SECTION 4.55(1A) MODIFICATION APPLICATION COCKLE BAY PARK, 241-249 WHEAT ROAD, COCKLE BAY

The purpose of this modification is to amend State Significant Development Consent SSD 7684 (the Stage 1 Concept Approval) to reflect the design competition winning scheme prepared by Henning Larsen and subsequent design refinement and resolution, which have necessitated minor modifications to the approved building envelope. Whilst there are a number of modifications proposed to the approved envelope, these modifications do not substantively alter the nature of the approved project, nor do they give rise to any significant environmental impacts, with the overall volume and form of the proposed building remaining well within the approved Concept Plan parameters.

Figure 1 Detailed elements of the northern podium (as part of the concurrent Stage 2 application) that require modifications to the approved envelope
 Source: Henning Larsen

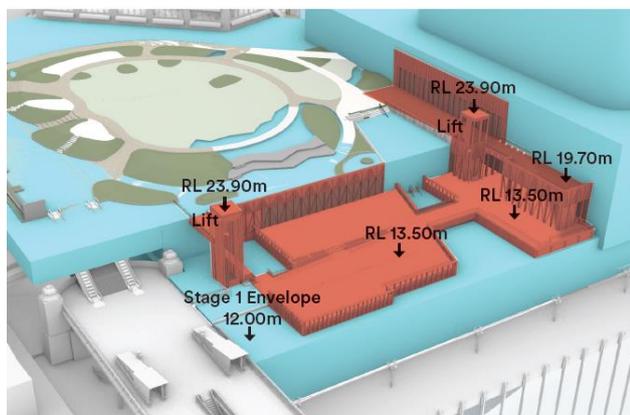
The building envelope at the podium levels is proposed to be modified. This includes minor, isolated increases to the levels to enable the provision of DDA compliant lifts and a ramp connection between the podium and Pymont Bridge, providing increased pedestrian and cycling amenity and public domain activation. These changes primarily arise due to the requirement to achieve suitable clearances above the Western Distributor and travel gradients to the podium and throughout the podium which are accessible and inclusive.

Further, minor refinements to the finished floor levels of the tower lobby and surrounding external spaces are required as a result of refinements to the landbridge structure over the Western Distributor.

The proposed envelope amendments to the podium are shown in **Figure 1** and **Figure 2** below. The Stage 1 approved envelope is shown in blue, with all modifications shown in red.

Figure 3 Detailed elements of the Northern Park (as part of the concurrent Stage 2 application) that require modifications to the approved envelope
 Source: Henning Larsen

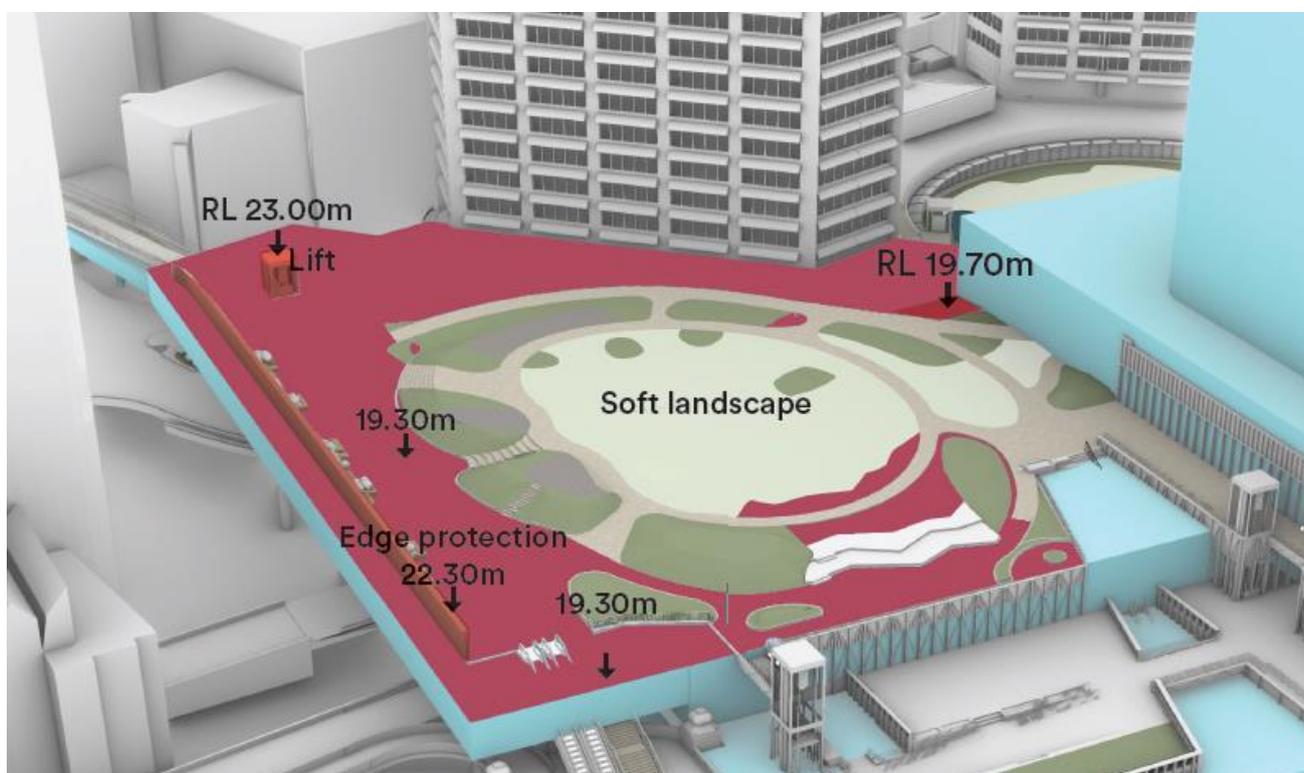
In order to provide sufficient soil depths for desired planting within the Northern Park, the landbridge's height in various locations is required to be increased. Further, a wall is proposed to be erected on the northern edge of the park to provide physical protection to the Western Distributor below as a requirement of TfNSW (RMS). A lift is also required to connect the landbridge to the Sussex Street plaza. These changes are shown **Figure 3** below, with the red indicating where the proposed development exceeds the current approved envelope.

Figure 4 Detailed elements of the proposed Pymont Bridge pedestrian connection (as part of the concurrent Stage 2 application) that require modifications to the approved envelope

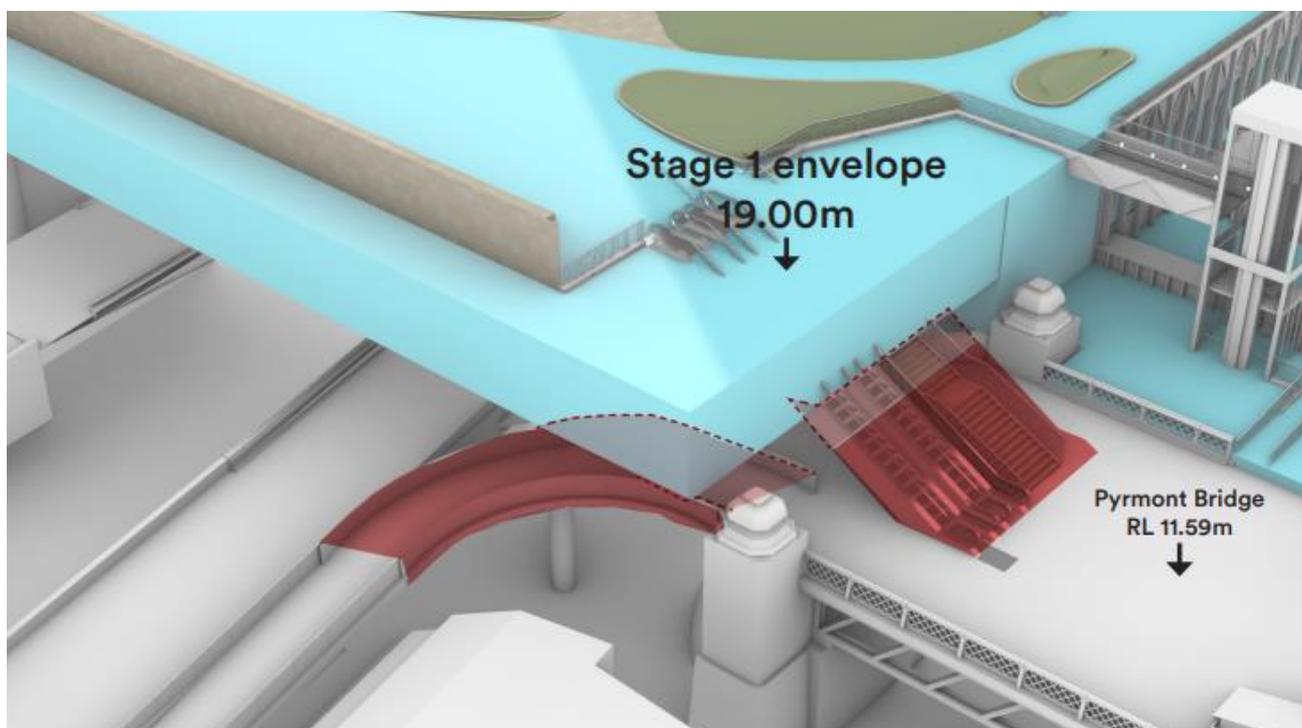
- Pymont Bridge** – the modified building envelope allows for stairs, escalators, and a realigned Harbour Street bicycle ramp at the interface between the landbridge and Pymont Bridge. This allows for access between Darling Harbour and Central Sydney, and have been designed to be sensitive to the heritage context of the Pymont Bridge. The proposed envelope modification relating to the Pymont Bridge connection is shown in **Figure 4**, with the approved envelope shown in blue and the proposed modifications shown in red.

Figure 5 Detailed elements of the Market Street Link (as part of the concurrent Stage 2 application) that require modifications to the approved envelope

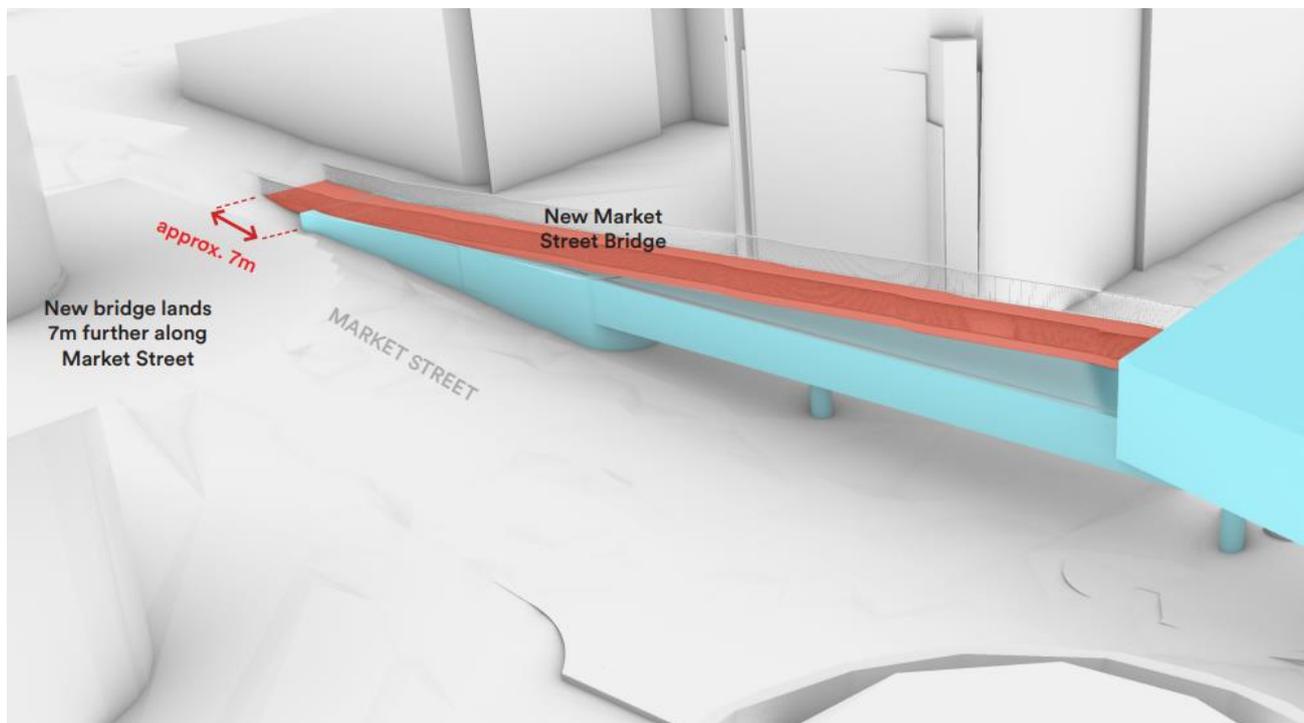
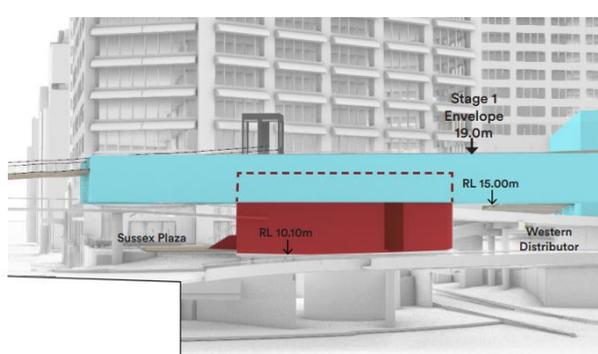
- Market Street Bridge** – similarly, modifications to the envelope are required to explicitly include the proposed new Market Street Bridge. A new bridge connection is needed to provide a DDA compliant access ramp from Market Street to the landbridge, over Sussex Street. The bridge is required to extend further along Market Street and slope to a higher level to connect to the landbridge and allow for safe vehicular passage below. Therefore, the envelope is required to be extended by approximately seven (7) metres along Market Street as shown in **Figure 5** below.

Figure 6 Detailed elements of the Sussex Plaza retail space (as part of the concurrent Stage 2 application) that require modifications to the approved envelope

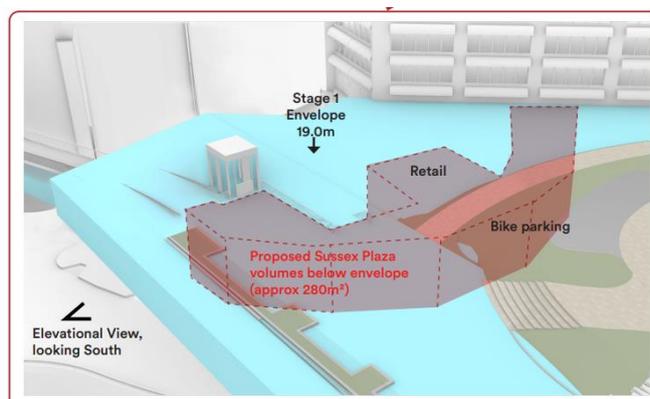
- Sussex Plaza** – finally, it is proposed to incorporate the existing retail space at the corner of Market Street and Sussex Street as part of the building envelope. This retail space will facilitate access to the landbridge above through the provision of stairs, escalators and a lift to provide equitable access. Further, the replacement of this retail space along with new public domain areas will activate the Sussex Street frontage of the site and act as an important gateway to the precinct. The modification is shown in **Figure 6** below, with the approved envelope shown in blue and the proposed modifications shown in red.

Figure 7 Detailed elements of the Crescent Garden Interface (proposed as part of the concurrent Stage 2 application) that require modifications to the approved envelope

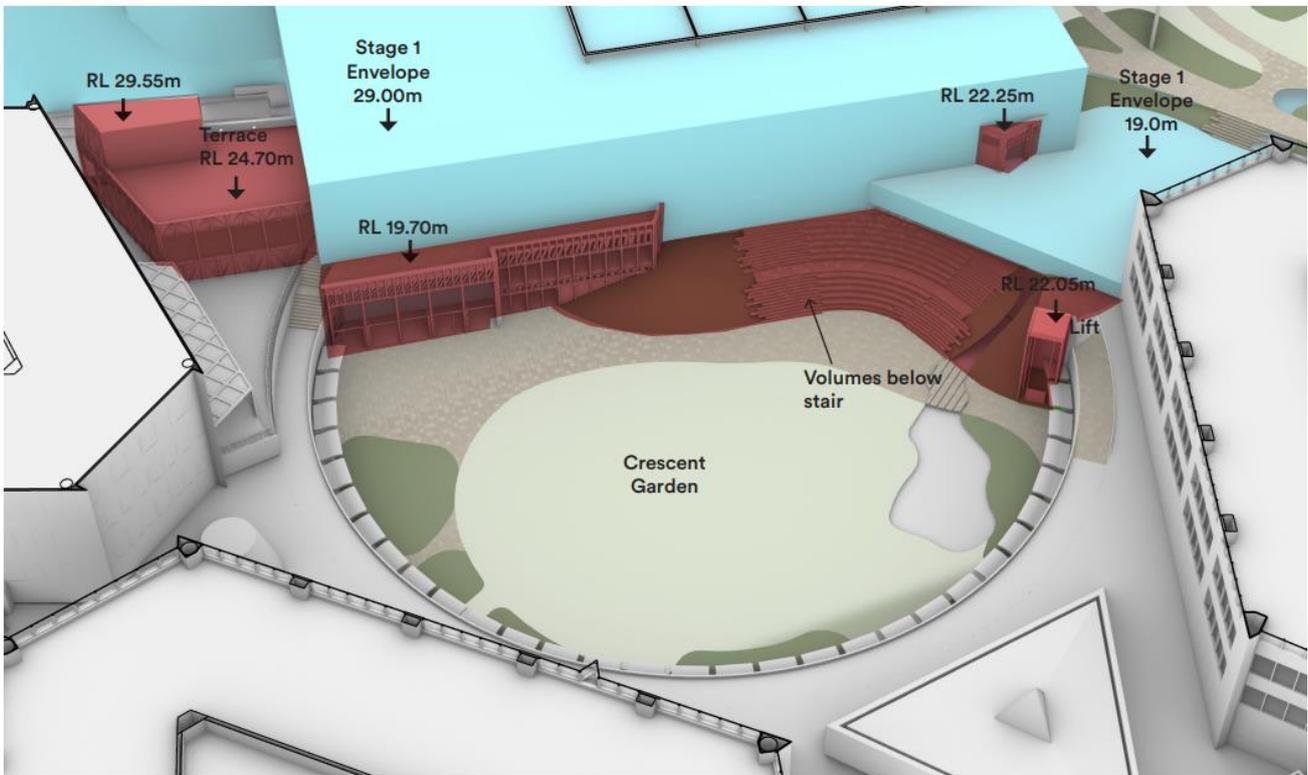
It is proposed to amend the building envelope to also enable it to interface with the Crescent Garden. The Stage 2 SSD DA proposes to include connections from the new tower to the Crescent Garden open space area, providing an improved relationship to the existing Darling Park precinct. In order to provide a high level of accessibility between these two areas, additional envelope volumes are required to facilitate this transition. The following will be incorporated within this additional volume as part of the Stage 2 detailed application:

- Amphitheatre stairs between the landbridge and Crescent Garden, as envisaged within the adopted Urban Design Guidelines for the site.
- Additional terracing to integrate with a proposed wellness centre.
- Lift access to both the wellness terrace and the landbridge.

The proposed modifications are shown in red in **Figure 7** below.

Figure 8 Detailed elements of the eastern façade (as part of the concurrent Stage 2 application) that require modifications to the approved envelope

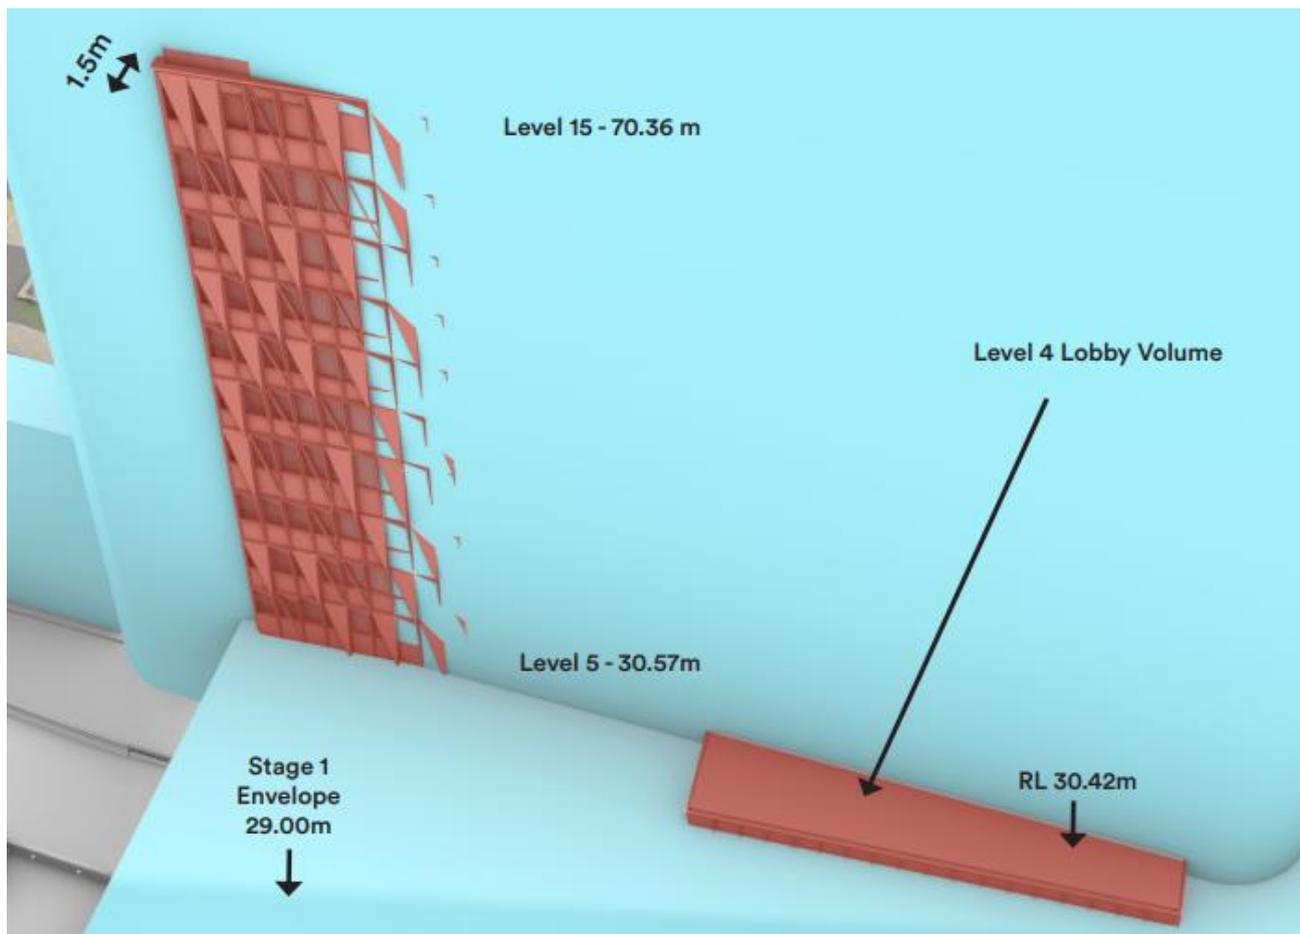
The eastern façade of the tower envelope is proposed to be modified to capture minor adjustments to the built form resulting from design development. The building envelope is required to be modified on the low-rise eastern façade to account for an adjusted footprint of the building to better articulate the building and optimise modulation of the façade. Further, a portion of the tower on level 4 breaches the envelope to the north-east, resulting from the raised level of the tower lobby on level 3 below. These changes are a result of architectural design development and are important in the articulation and detailing of the building.

The changes are illustrated in **Figure 8** below.

Figure 9 Detailed elements of the western facade(as part of the concurrent Stage 2 application) that require modifications to the approved envelope Source: Henning Larsen

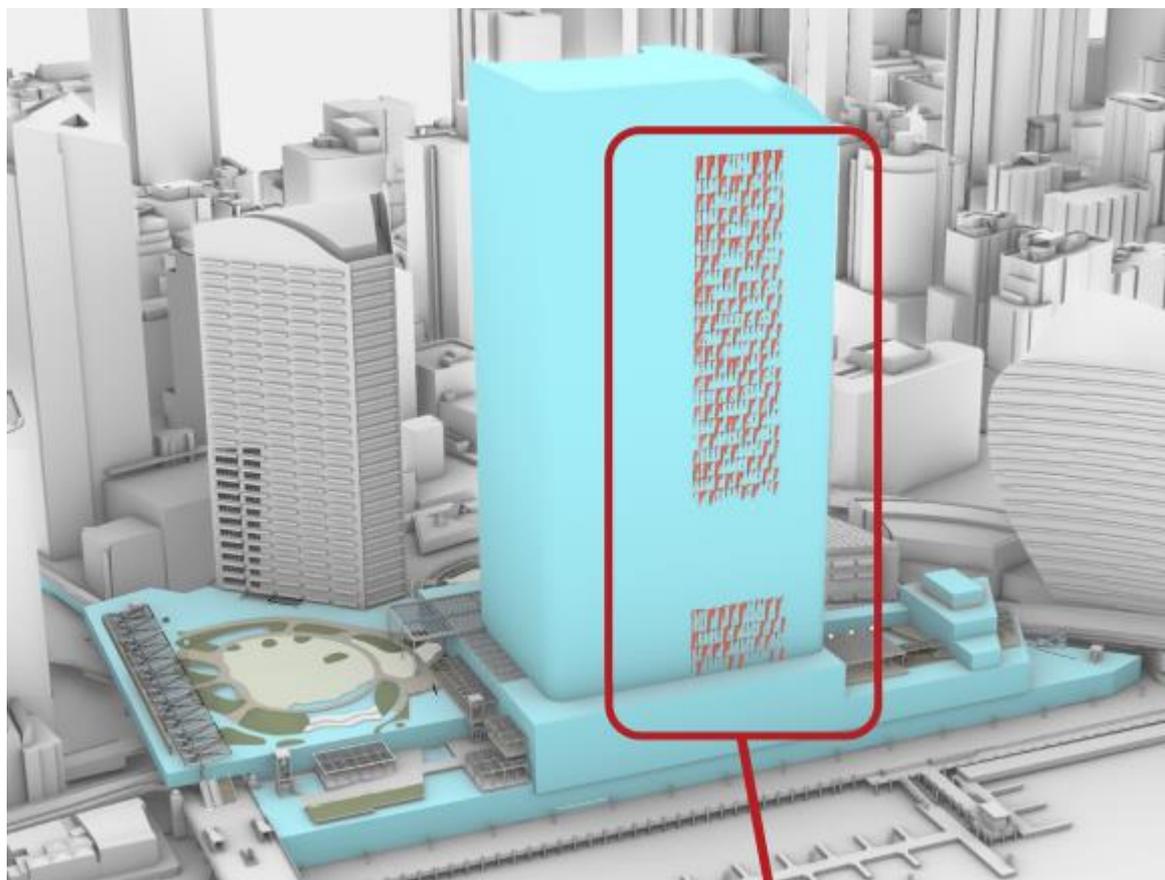
The western facade of the tower contains several small envelope breaches resulting from the articulation of the façade, comprising the hooded window elements that were a key aspect of the design competition-winning scheme. These façade elements are minor and do not constitute any gross floor area, and instead are proposed to improve façade performance and optimise modulation.

The proposed envelope modification is shown in red in **Figure 9** and **Figure 10** below.

Figure 10 Area of the façade detailing that breaches the envelope shown in red Source: Henning Larsen

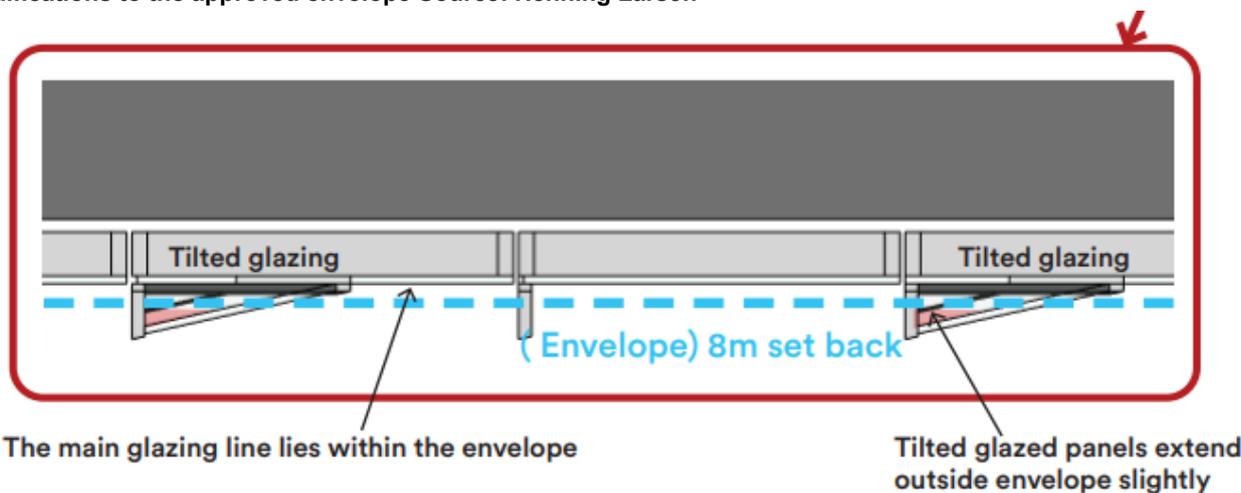
The main glazing line lies within the envelope

Figure 11 Detailed elements of the podium pergolas (as part of the concurrent Stage 2 application) that require modifications to the approved envelope

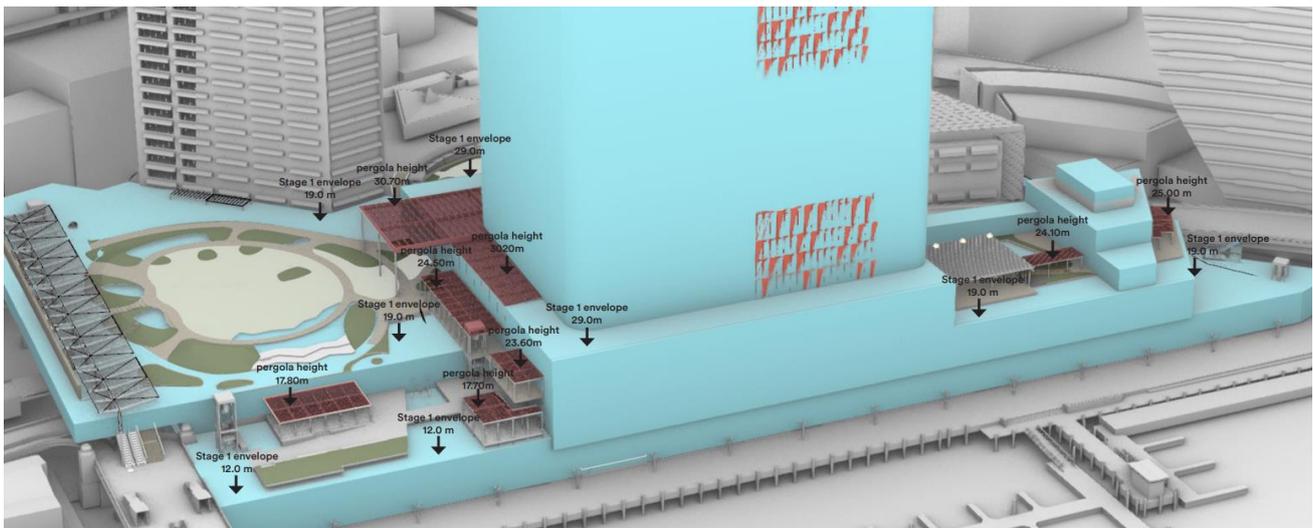
The envelope is also proposed to be modified in several locations in order to accommodate pergolas around the base of the building, associated with the retail podium, as well as shelter for vertical transport elements, such as escalators. As discussed further in **Section 7.5**, these pergolas are integral in improving the pedestrian comfort and experience in the public domain and retail podium.

The pergolas requiring envelope modifications are shown in **Figure 11**.
